STAFF REPORT INFORMATION ONLY

Request for approval of variances from the former City of Scarborough Sign By-law No. 22980, as amended, for one ground sign and five signs on five tower steel structures at 1399 Kennedy Road.

Date:	April 16, 2007		>	22
To:	Chair and Members, Scarborough Community Council		2	0110
From:	Director, Toronto Building, Scarborough District			*****
Wards:	Scarborough Centre – Ward 37			
Reference Number:	2007SC007

ATTACHMENT 3 - GROUND SIGN

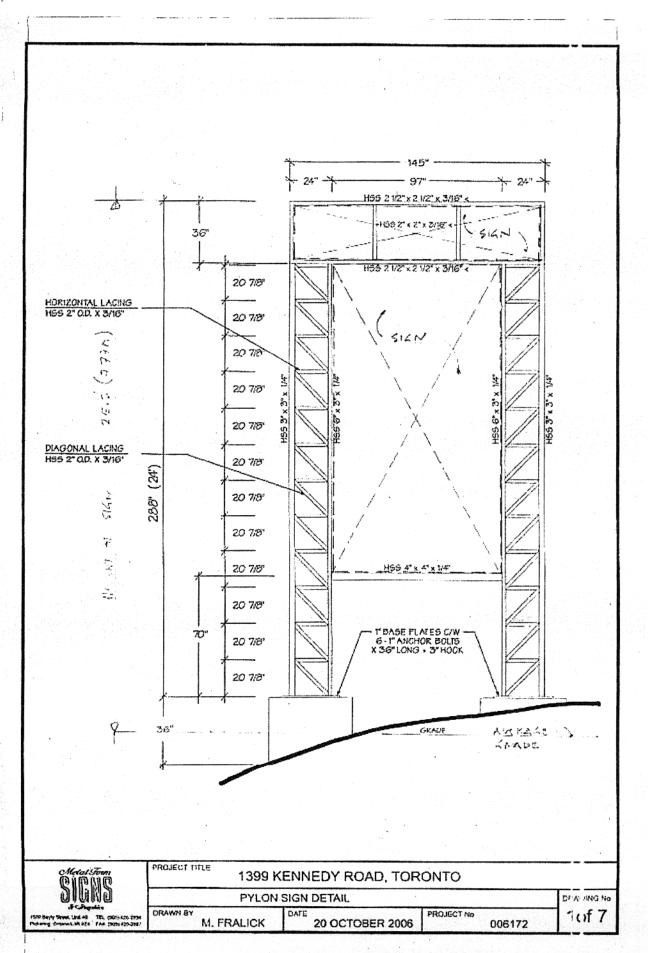
Sign By-law Section & Requirements	Applicant's Proposal	Required Variance
2.3.5(2)(a) Not more than one identification or business or promotional advertising ground sign shall be erected per premises per street frontage.	To erect six ground signs per premise per street frontage.	To allow the erection of six ground signs per premise per street frontage, while only one ground sign is permitted. The number of proposed signs is greater than the permitted number of signs by 5 or 500%.

2.3.5(4)(d) The maximum area per sign face, with respect to ground sign identification or business or promotional advertising sign faces only, shall not exceed, for Group 4 Use premises, the greater of 7m ² or 1m ² for each 15m of street frontage.	To erect six ground sign having an overall sign area of 70.33m ² .	To allow the erection of six ground signs having an overall sign area of 70.33m ² , while the permitted sign area is 11.48m ² . Proposed sign area is 58.85m ² or 512.63%, larger than the permitted area.

ATTACHMENT 4 - TOWER SIGNS

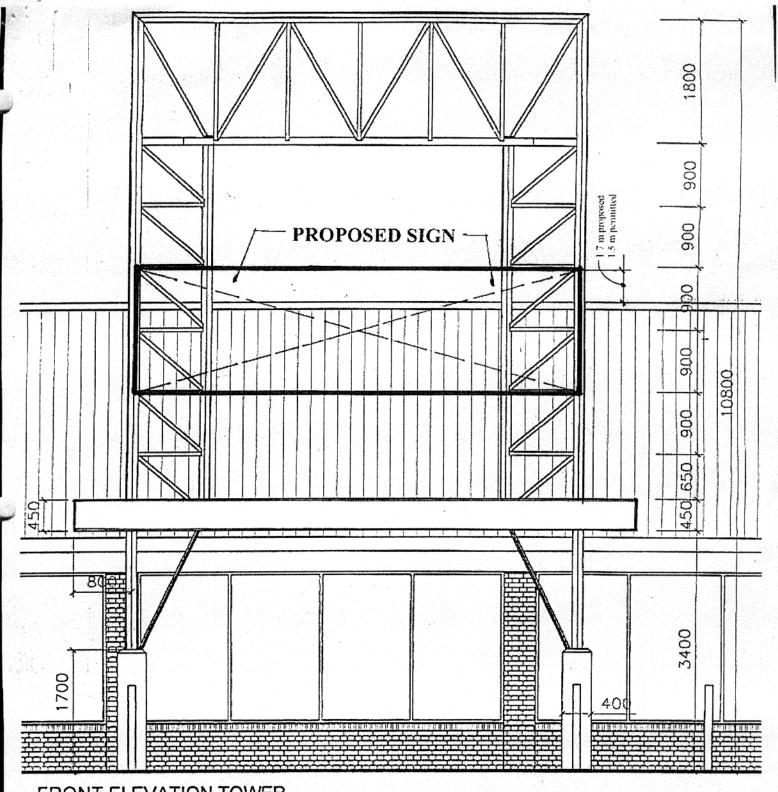
The five steel tower structures are spaced along the west wall of the building facing Kennedy Road. Each tower is 6.2m wide by 2m deep by 10.8m high and is erected 1.3m away the face of the wall. A 3.4 m high canopy is also incorporated into each tower.

If the five signs that are proposed to be attached to the towers were considered as ground signs, then the number of ground signs on this property, including the single ground sign proposed near the driveway off Kennedy Road, will total six, The number of proposed ground signs, their aggregate sign area, the height of each sign from the ground and the distance between the signs would not be in compliance with the requirements of the Sign By-law. The following table describes in greater detail the by-law requirements, the requested variances and the extent of the non-compliance.

2.3.5(5) (a) (ii) The maximum permitted height of a sign face above grade shall not exceed 1m for each 1.5m ² of permitted sign face area, for permitted areas in excess of 10m ²	To erect five ground signs with each having an overall height of 8.38m	To allow the erection of five ground signs with having an overall height of 8.38m., while the permitted overall sign height is 7.65m. The proposed sign height is 0.73m, or 9.54% greater than the permitted height

To erect ground signs with a distance separation between signs of 10m to 14m

To allow the erection of ground signs with a distance separation between signs of 10m to 14m., while the required distance separation is 150m

The proposed distance separation is 140m to 136m or 93% to 91% less than the required separation
